Changes to proposed District Map Amendment G-956

A revised version of DMA G-956, dated December 18, 2013, has been posted on the Planning Department website for review. It contains all of the proposed and approved changes that have occurred since October 11, 2013. The following document illustrates all of the changes to DMA G-956.

Changes made to DMA G-956 are organized into four sections, each section describing a different type of revision.

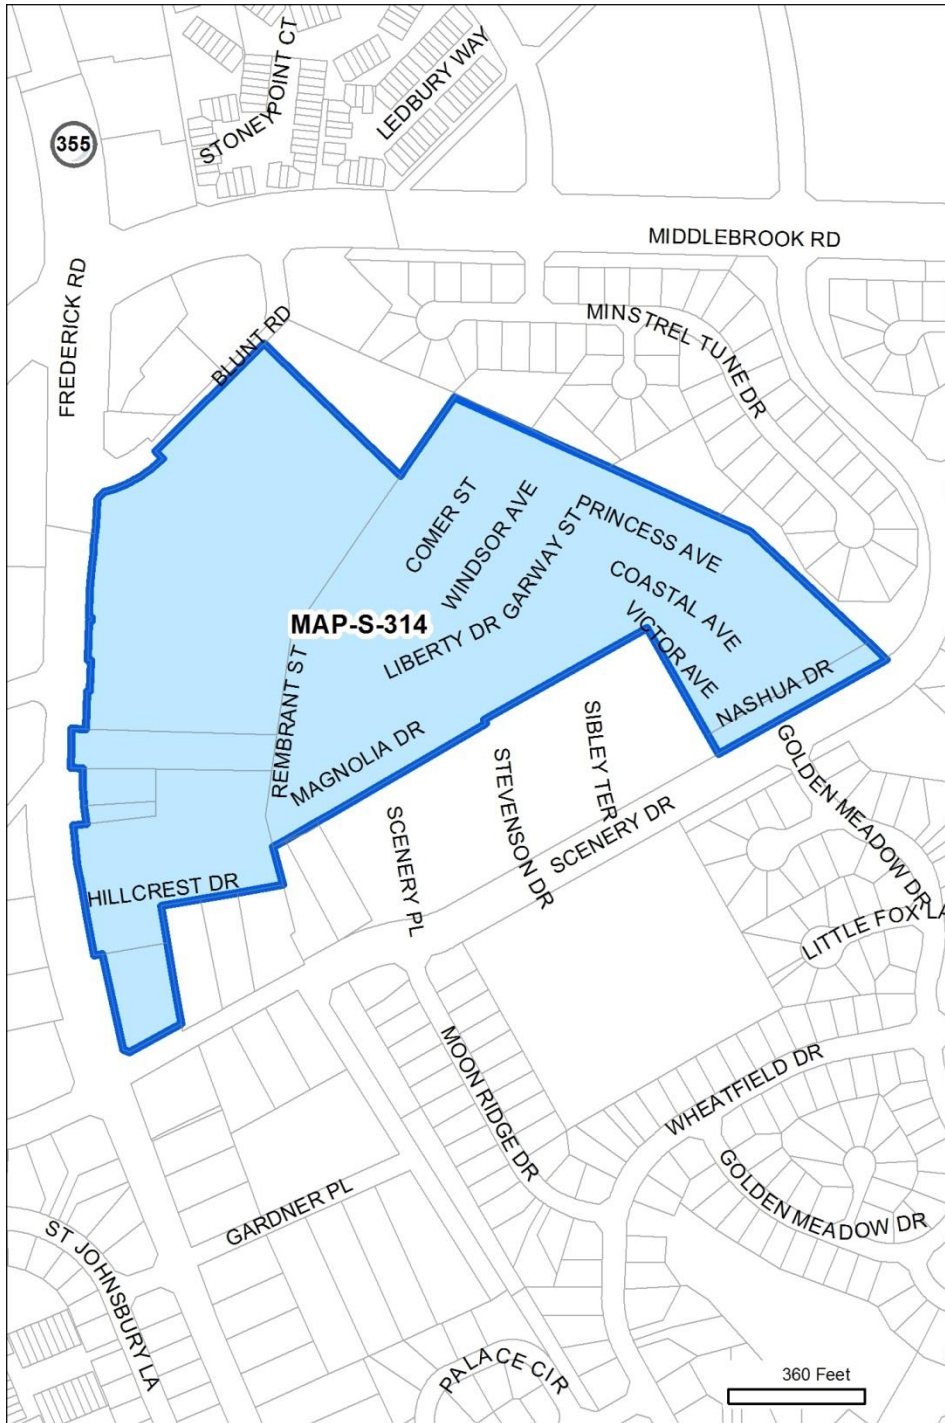
Unique ID: MAP-S-314		staff recommendation
Master Plan ID: GRMTC-28		
Master Plan:		Germantown Town Center
Location:		
Existing Zone:		RMX-2C/TDR
Proposed Conv: (10/11)		CRT-1.25 C-0.5 R-1.0 H-60 T
Prop. Revised Conv:		CRT-1.25 C-0.5 R-0.75 H-60 T
Category:		Staff Recommendation
Modifications	Zone Group:	No change
	Overall FAR:	No change
	Comm'l FAR:	No change
	Resid'l FAR:	Reduced to 0.75
	Height:	No change
Reason for change:		
<p><i>This area is currently zoned RMX-2C/TDR.</i></p> <p><i>The Zoning Ordinance limits non-TDR development to 14.52 dwelling units per acre in this zone. Additional density is available only through the purchase of TDRs</i></p> <p><i>Staff is proposing changes to the TDR Overlay in terms of how it interfaces with mixed-use zones. This change requires that only the base (non-TDR) density be mapped.</i></p> <p><i>The full density will still be achievable because the TDR Overlay sits on top of the CRT zone and will allow the density as specified in the Sector Plan.</i></p> <p><i>In this case, the base density of 14.52 dwelling units per acre will fall between 0.48 and 0.80 FAR, depending on the mix of unit types.</i></p> <p><i>Therefore, the residential FAR should be reduced.</i></p>

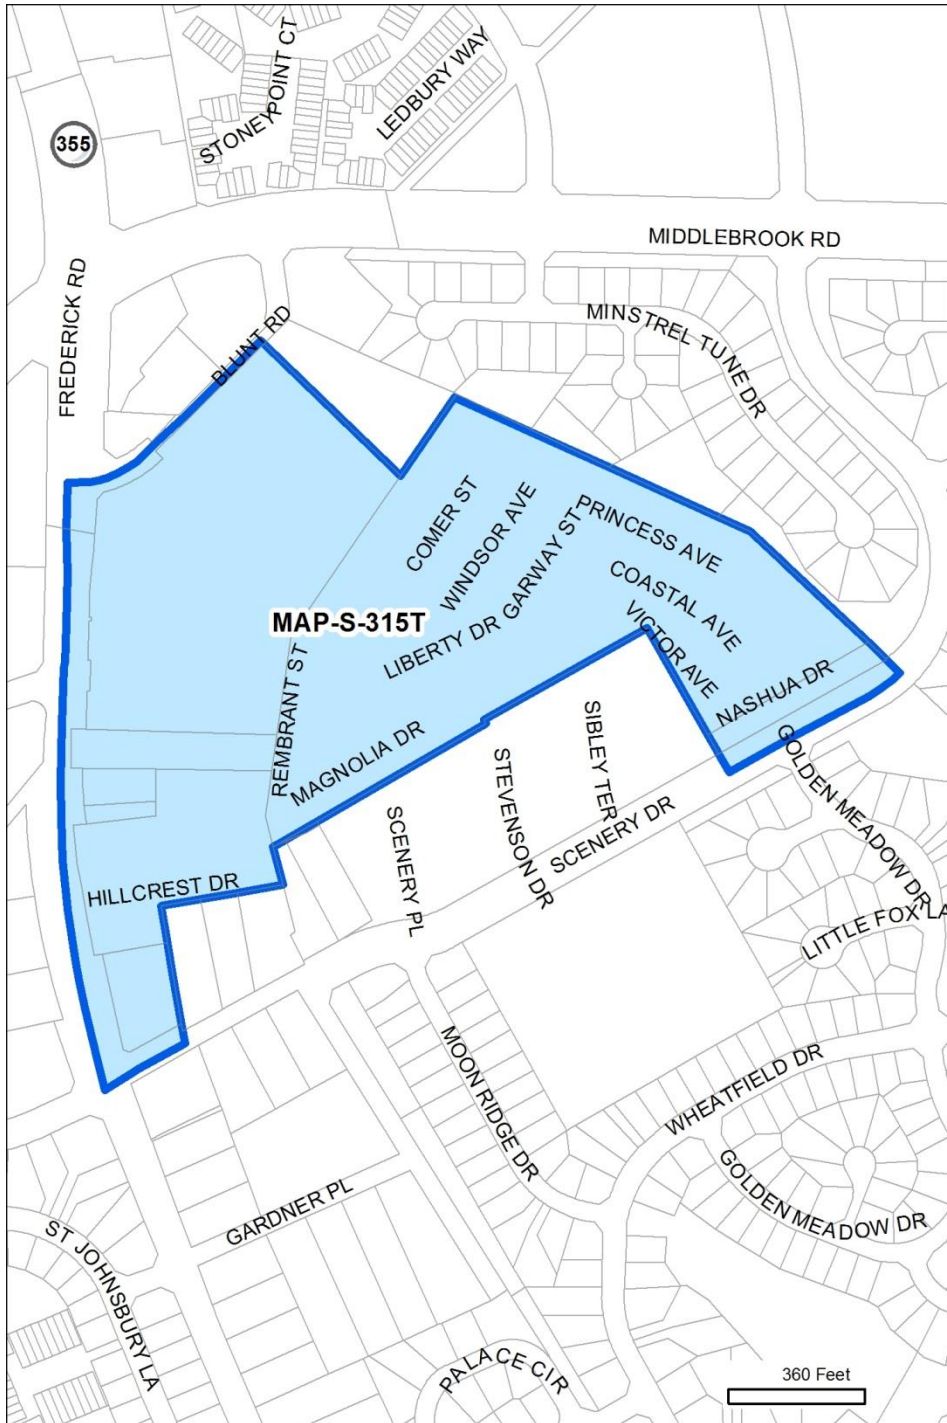
Unique ID: MAP-S-315T		staff recommendation
Master Plan ID: GRMTC-28		
Master Plan:	Germantown Town Center	
Location:	Blunt Road & Route 355	
Existing Zone:	RMX-2C/TDR	
Proposed Conv: (10/11)	TDR-22.0	
Prop. Revised Conv:	TDR-20.4	
Category:	Staff Recommendation	
Modifications	Zone Group:	-
	Overall FAR:	-
	Comm'l FAR:	-
	Resid'l FAR:	-
	Height:	-
Reason for change:		
<p><i>This area is currently in the RMX-2C/TDR zone.</i></p> <p><i>As a result, it is being added as a receiving area in the proposed TDR Overlay. Changes currently proposed for the overlay will result in a changed value for the TDR.</i></p> <p><i>However, at this time, the new value has not been determined.</i></p>

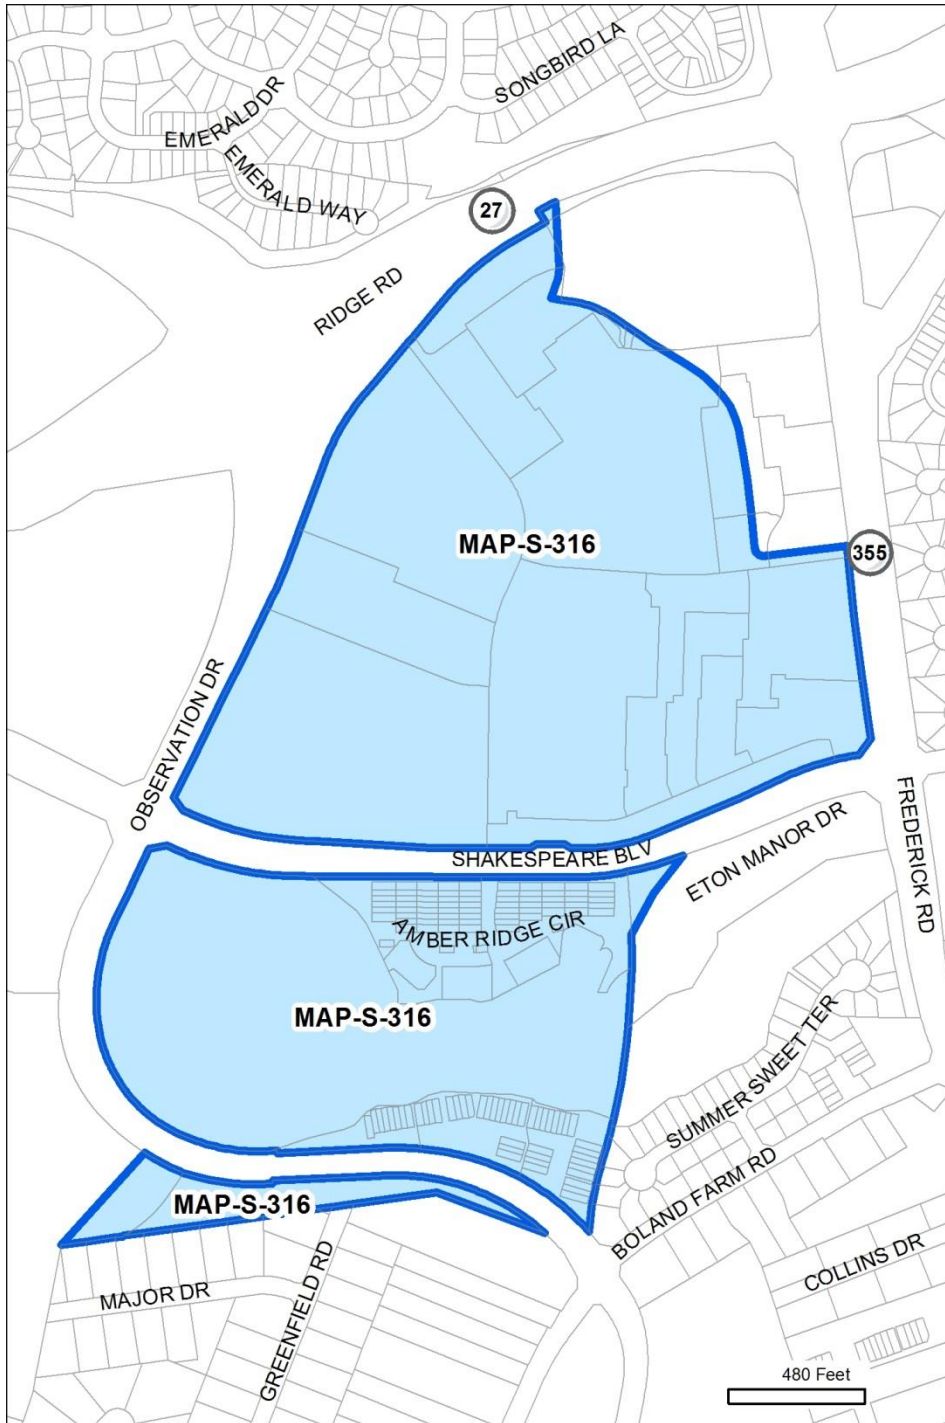
Unique ID: MAP-S-316		staff recommendation
Master Plan ID: GRMTC-31		
Master Plan:		Germantown Town Center
Location:		
Existing Zone:		RMX-3/TDR
Proposed Conv: (10/11)		CRT-2.0 C-0.5 R-1.5 H-65 T
Prop. Revised Conv:		CRT-0.75 C-0.5 R-0.25 H-65 T
Category:		Staff Recommendation
Modifications	Zone Group:	No change
	Overall FAR:	Reduced to 0.75
	Comm'l FAR:	No change
	Resid'l FAR:	Reduced to 0.25
	Height:	No change
Reason for change:		
<p><i>This area is currently zoned RMX-3/TDR.</i></p> <p><i>The Zoning Ordinance limits non-TDR development to 2.18 dwelling units per acre in this zone. Additional density is available only through the purchase of TDRs</i></p> <p><i>Staff is proposing changes to the TDR Overlay in terms of how it interfaces with mixed-use zones. This change requires that only the base (non-TDR) density be mapped.</i></p> <p><i>The full density will still be achievable because the TDR Overlay sits on top of the CRT zone and will allow the density as specified in the Sector Plan.</i></p> <p><i>In this case, the base density of 2.18 dwelling units per acre will fall between 0.07 and 0.12 FAR, depending on the mix of unit types.</i></p> <p><i>Therefore, the residential and overall FAR should be reduced.</i></p>

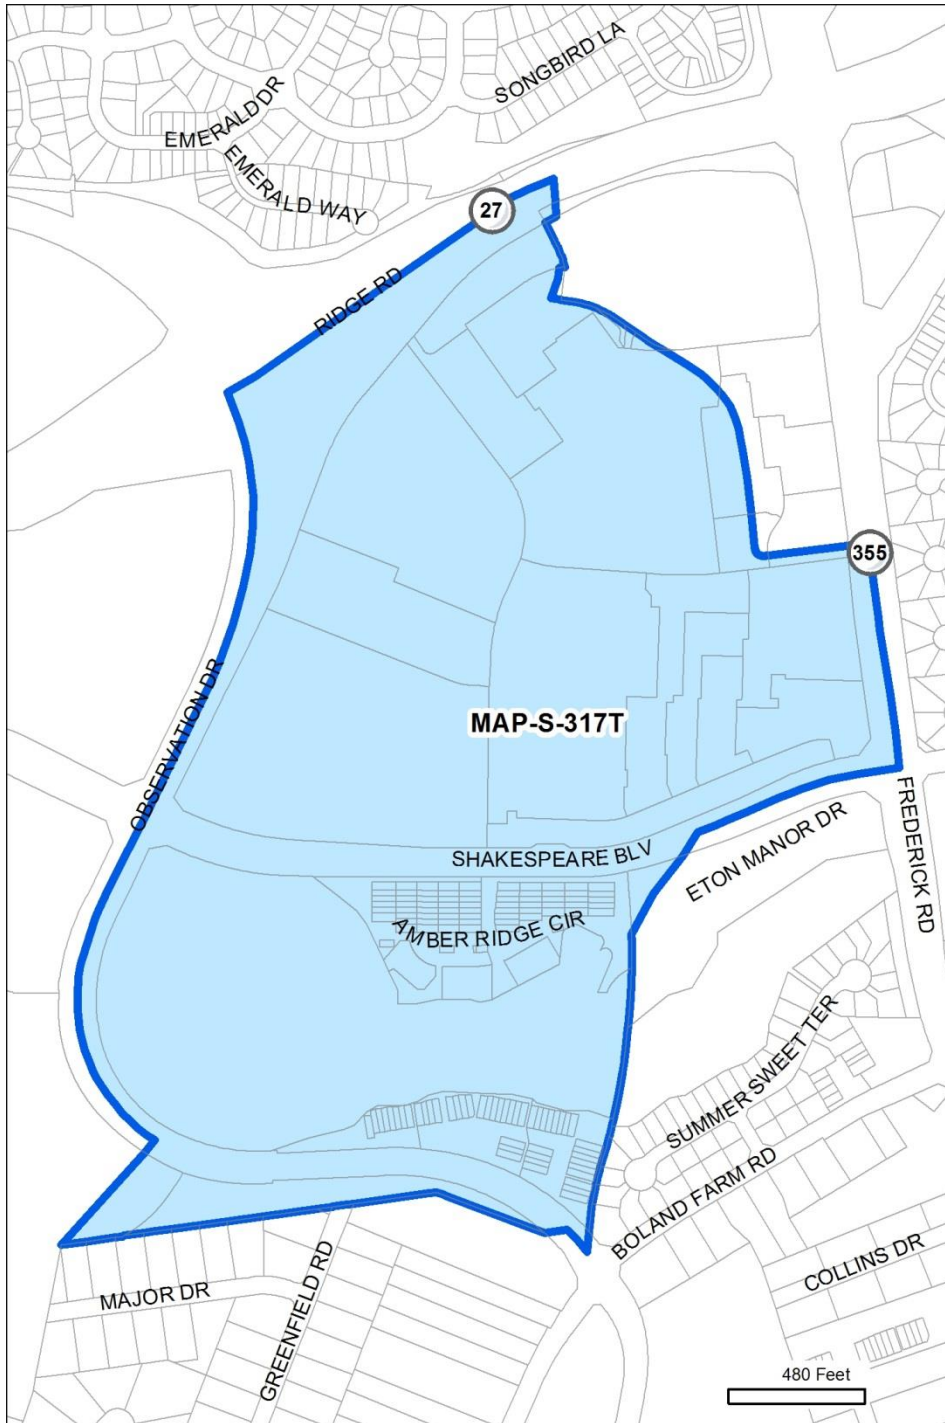
Unique ID: MAP-S-317T		staff recommendation
Master Plan ID: GRMTC-31		
Master Plan:	Germantown Town Center	
Location:	Milestone Center	
Existing Zone:	RMX-3/TDR	
Proposed Conv: (10/11)	TDR-6.0	
Prop. Revised Conv:	TDR-30.2	
Category:	Staff Recommendation	
Modifications	Zone Group:	-
	Overall FAR:	-
	Comm'l FAR:	-
	Resid'l FAR:	-
	Height:	-
Reason for change:		
<p><i>This area is currently in the RMX-3/TDR zone.</i></p> <p><i>As a result, it is being added as a receiving area in the proposed TDR Overlay. Changes currently proposed for the overlay will result in a changed value for the TDR.</i></p> <p><i>However, at this time, the new value has not been determined.</i></p>

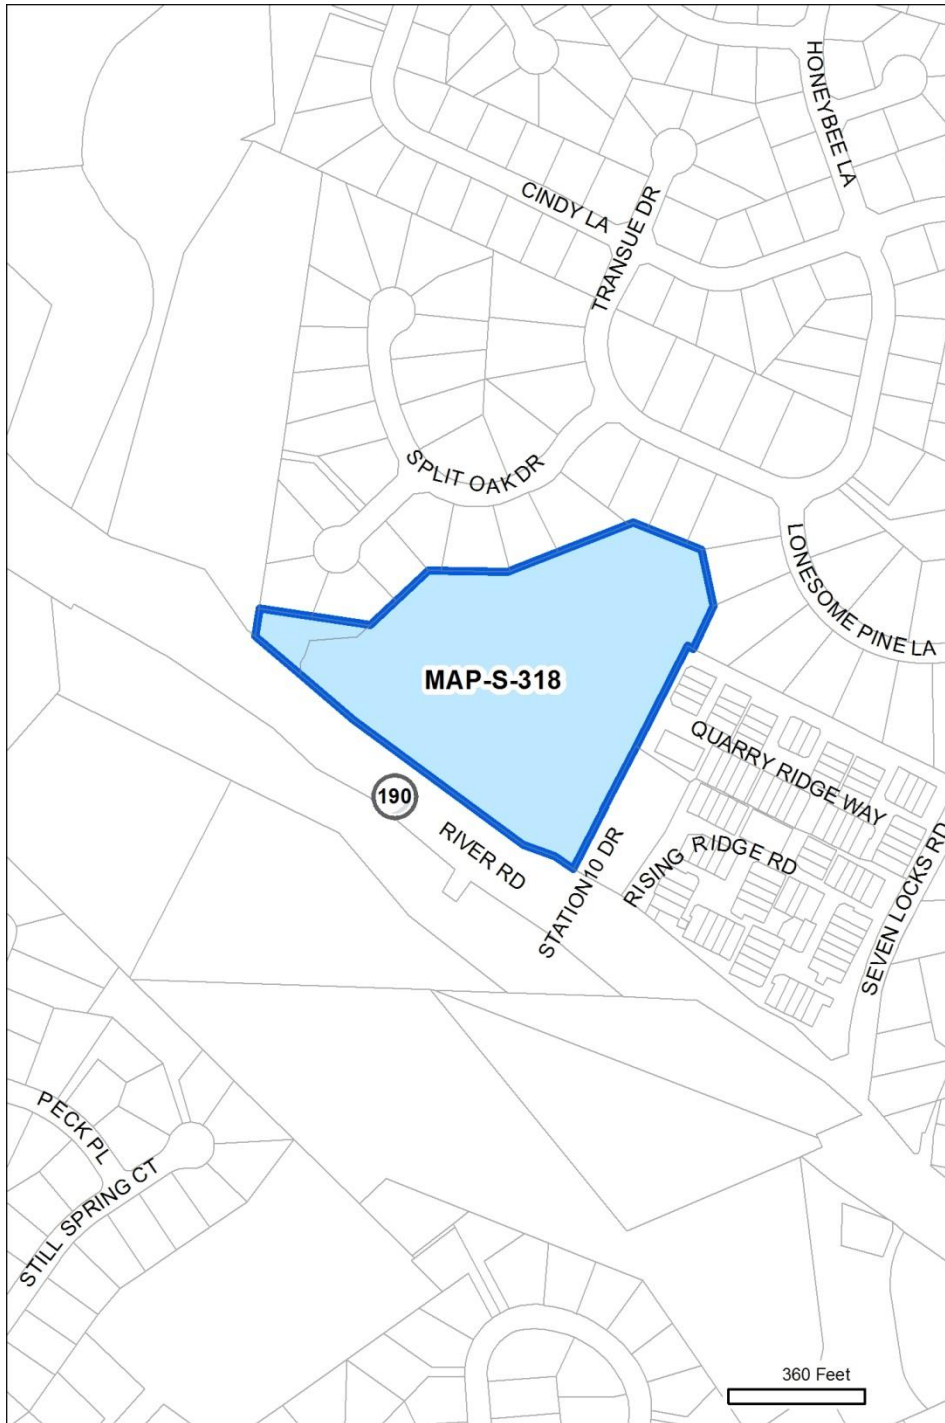
Unique ID: MAP-S-318		staff recommendation
Master Plan ID: POTMC-07		
Master Plan:	Potomac Subregion	
Location:		
Existing Zone:	RMX-1/TDR	
Proposed Conv: (10/11)	CRT-0.5 C-0.25 R-0.5 H-60 T	
Prop. Revised Conv:	CRT-0.5 C-0.25 R-0.25 H-60 T	
Category:	Staff Recommendation	
Modifications	Zone Group:	No change
	Overall FAR:	No change
	Comm'l FAR:	No change
	Resid'l FAR:	Reduced to 0.25
	Height:	No change
Reason for change:		
<p><i>This area is currently zoned RMX-1/TDR.</i></p> <p><i>The Potomac Subregion Master Plan recommends this area for a maximum density of 97 DUs, achievable only through TDRs.</i></p> <p><i>Staff is proposing changes to the TDR Overlay in terms of how it interfaces with mixed-use zones. This change requires that only the base (non-TDR) density be mapped.</i></p> <p><i>The full density will still be achievable because the TDR Overlay sits on top of the CRT zone and will allow the density as specified in the Sector Plan.</i></p> <p><i>In this case, the base density of 80 dwelling units will be approximately 0.20 FAR.</i></p> <p><i>Therefore, the residential FAR should be reduced.</i></p>

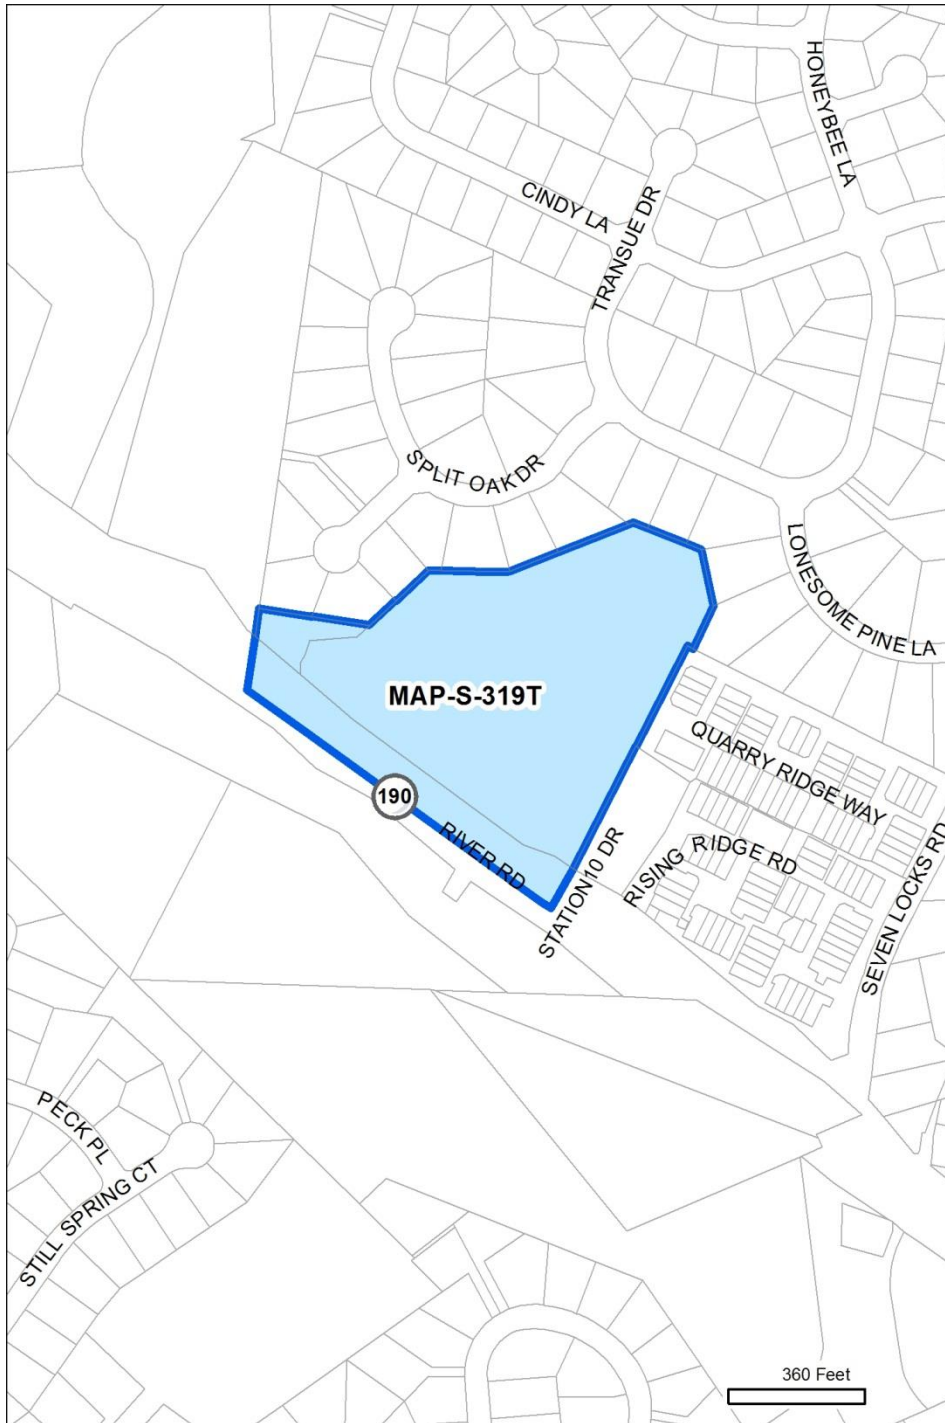
Unique ID: MAP-S-319T		staff recommendation
Master Plan ID: POTMC-07		
Master Plan:	Potomac Subregion	
Location:	Stonyhurst Quarry	
Existing Zone:	RMX-1/TDR	
Proposed Conv: (10/11)	TDR-6.0	
Prop. Revised Conv:	TDR-0.8	
Category:	Staff Recommendation	
Modifications	Zone Group:	-
	Overall FAR:	-
	Comm'l FAR:	-
	Resid'l FAR:	-
	Height:	-
Reason for change:		
<p><i>This area is currently in the RMX-1/TDR zone.</i></p> <p><i>As a result, it is being added as a receiving area in the proposed TDR Overlay. Changes currently proposed for the overlay will result in a changed value for the TDR.</i></p>

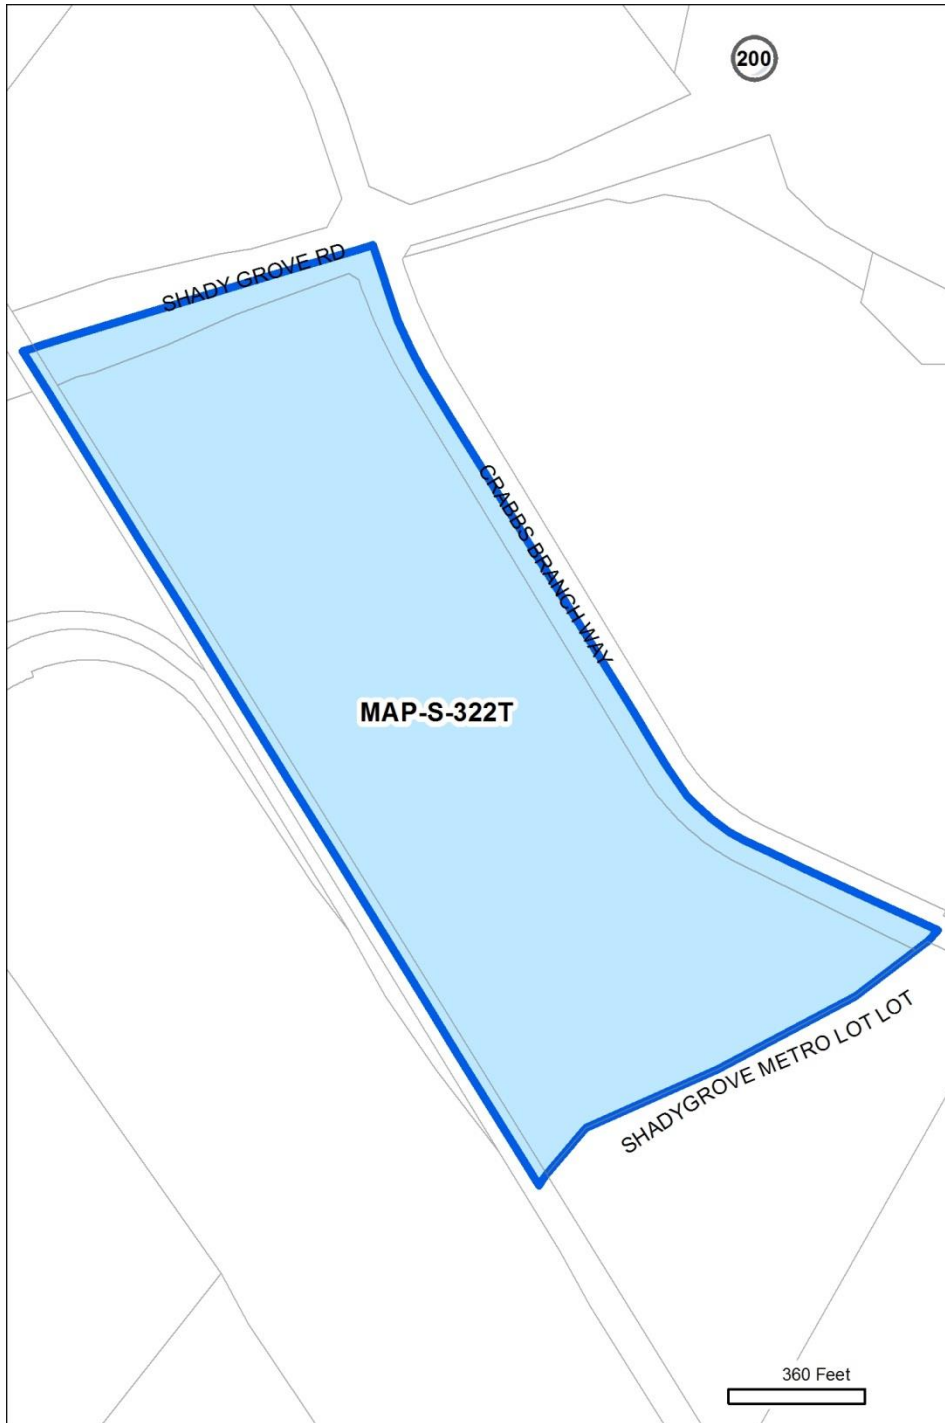
Unique ID: MAP-S-322T		staff recommendation
Master Plan ID: SDYGR-05		
Master Plan:	Shady Grove	
Location:		
Existing Zone:	TOMX-2/TDR	
Proposed Conv: (10/11)	TDR-22.0	
Prop. Revised Conv:	TDR-2.2	
Category:	Staff Recommendation	
Modifications	Zone Group:	-
	Overall FAR:	-
	Comm'l FAR:	-
	Resid'l FAR:	-
	Height:	-
Reason for change:		
<p><i>This area is currently in the TOMX-2/TDR zone.</i></p> <p><i>As a result, it is being added as a receiving area in the proposed TDR Overlay. Changes currently proposed for the overlay will result in a changed value for the TDR.</i></p>
